SUNDRY NOTICES AND REPORTS ON WELLS
Do not use this form for proposals to drill or to re-enter an abandoned well. Use Form 3160-3 (APD) for such proposals.

EL ZORRO E FEDERAL #004

El Zorro E Federal #4 P&A Summary

**Permanent Abandonment of Federal Wells
Conditions of Approval**

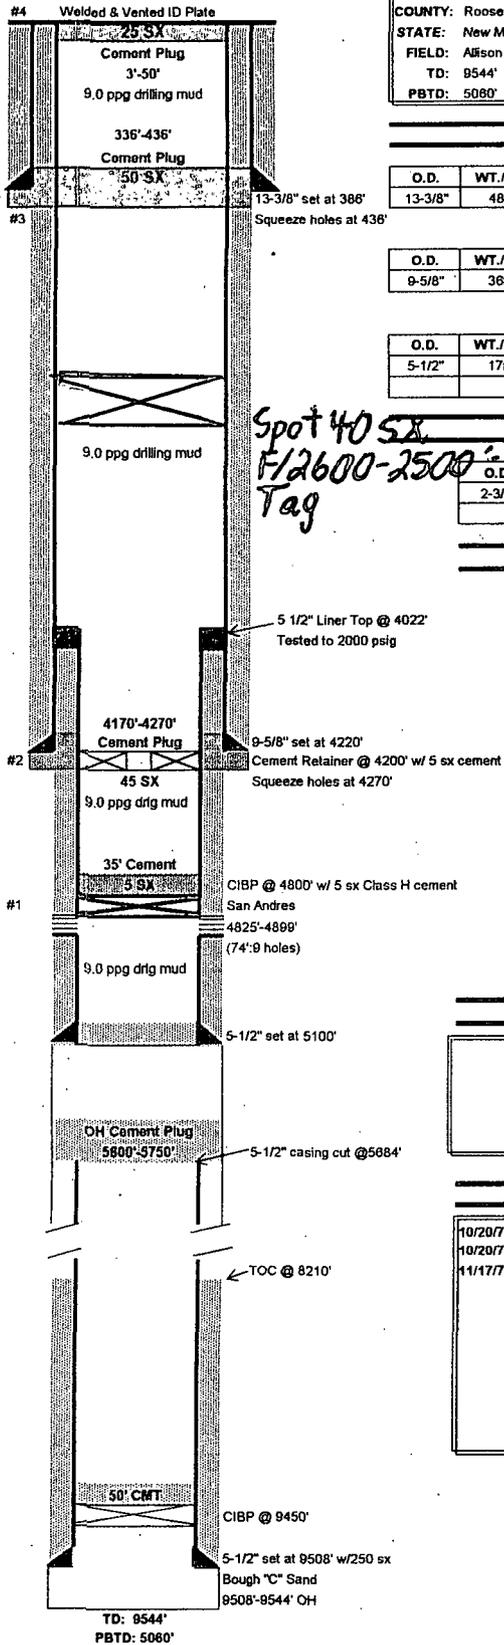
10. Mix and pump 50 sx Class "H" cement into holes (**Plug #2: 4170'-4270'KB**). Displace cement slurry w/15 bbls fresh water (45 sx below retainer).
11. Leave 5 sx cement on top of retainer. *Spot 40 SX. F/2600-2500-Tag*
